## 23/0113/RES - Approval of reserved matters of appearance, landscaping, layout and scale in relation to outline permission 19/1461/OUT as amended by 22/1520/NMA for a mixed use development to provide town centre facilities. | Land North Of Honiton Road And West Of Fitzroy Road Exeter

Exeter Cycling Campaign would like to **object** to the reserved matter application relating to a retail park on Fitzroy Road. The reasons for this objection are:

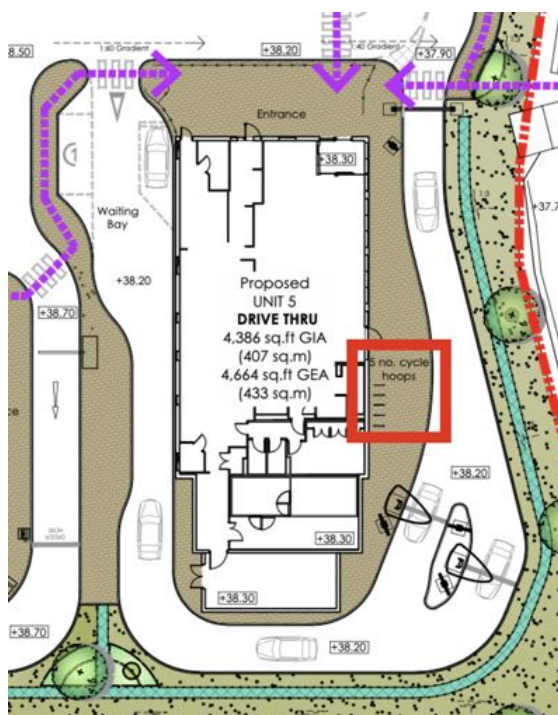
The Proposed Pedestrian Links document included in this reserved matter application suggests positions in which cycle parking might be provided. The first example shown here indicates the cycle parking is provisioned away from the main entrance to the restaurant,

accessed via a road on which drive-thru traffic will be queuing. This is not safe, nor convenient. Cycle parking should be located in a convenient and safe to access location at the front of the restaurant.

There is no cycle parking planned outside the supermarket according to the Proposed Pedestrian Links plan. This despite the supermarket being a key “town centre” facility. There are around 100 car parking spaces closer to the supermarket entrance than the nearest cycle parking space. People using these cycle spaces must cross two roads to reach the supermarket, with these crossings not provided as raised platforms.

- Provide cycle parking in safe and convenient locations around the site next to each retail unit to align with the developer's stated ambition to "*minimise car usage and to encourage walking, cycling and the use of public transport.*" (DAS, 6.1).
- Favour facilities for those using active transport by ensuring walking and cycling is more convenient than driving and parking on the site. This can be done by moving car parking for non-disabled users further from retail units to provide more space for pedestrians and cyclists.
- Make crossings into raised platforms to make them more accessible for disabled users, pushchairs, etc. This will also act to slow traffic around the site.

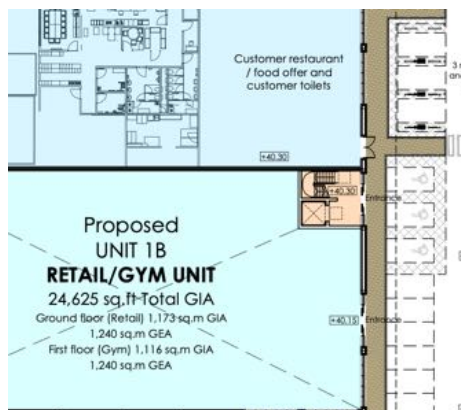
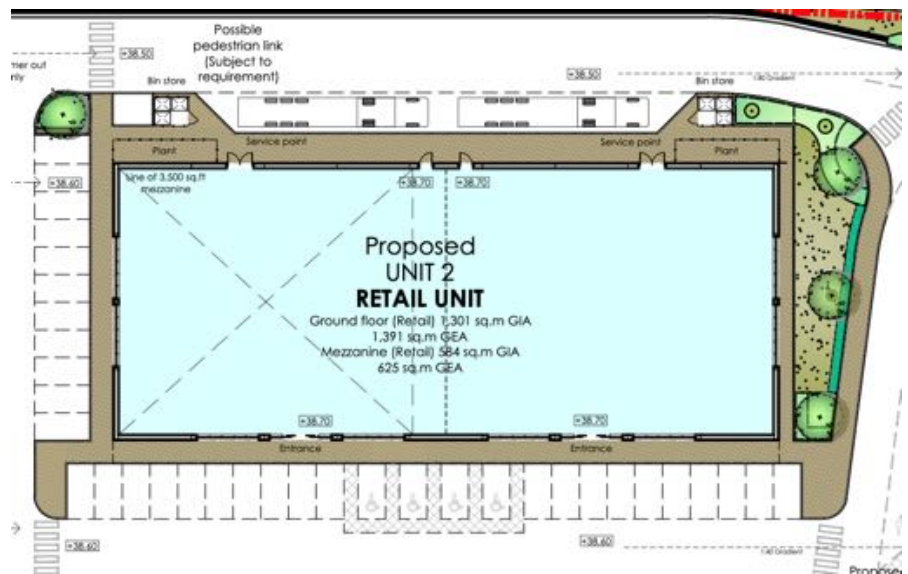
The pedestrian curtilage around the various retail units on this site as planned is insufficient. Consider retail unit 2 shown right. The pavement across the store fronts is narrower than the width of a single parking space. This forces pedestrians up against cars that are manoeuvring into parking spaces. It introduces conflict between people walking, using trolleys, or mobility scooters. Parents with children must remain extremely vigilant as there is no allowance for children running out of stores. As a brand new site that strives to provide “town centre facilities” the current plans are failing in the basic necessity of giving people space.

Another example of the parsimonious allocation of space to people walking on the site is shown left, this time outside the supermarket and retail unit 1b. The developer should be making more space available to people walking and cycling around the site.

- Increase the pedestrian curtilage around each unit so there is space for people to comfortably use the site without conflict.
- Make all other pavements on the site wider, including the ramp from Honiton Road.
